Reply

Orientation Control System: Enhancing Aerial Maneuvers for Quadruped Robots

Dear Reviewer,

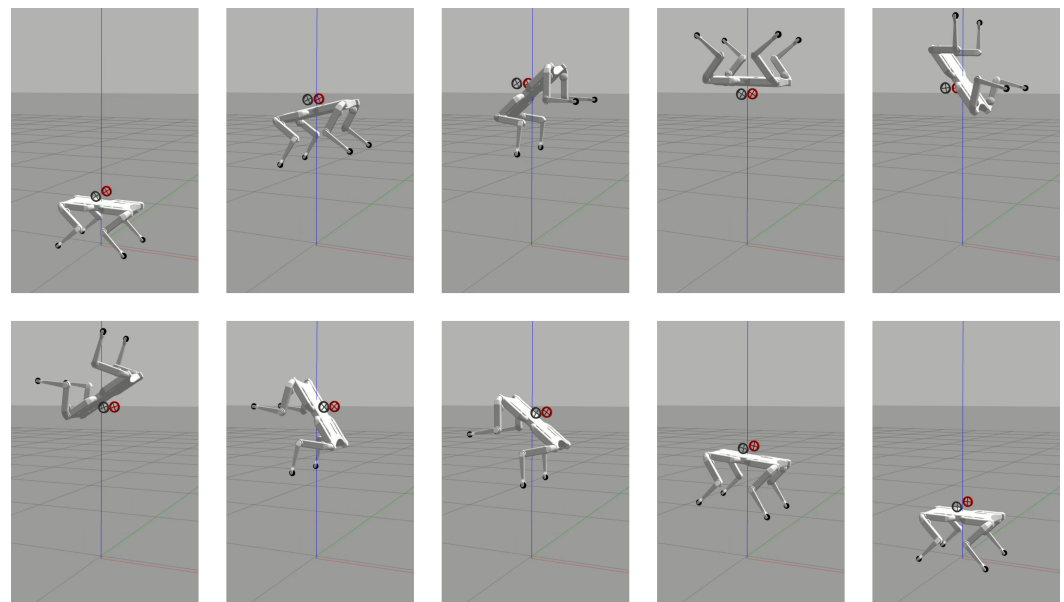
- **Comment 1:** 'All the simulations are performed in Gazebo'. The paper must have more details related with the simulation, including a snapshot of the simulated robot in its environment.

Response: Thank you for the insightful comment. We summarized the details of the simulation in Table 1, which is incorporated to the manuscript too. Moreover, inspired by your suggestion, we attached a sequence of snapshots for the third simulation (back-flip), showing the robot in the Gazebo environment (Fig. 1)
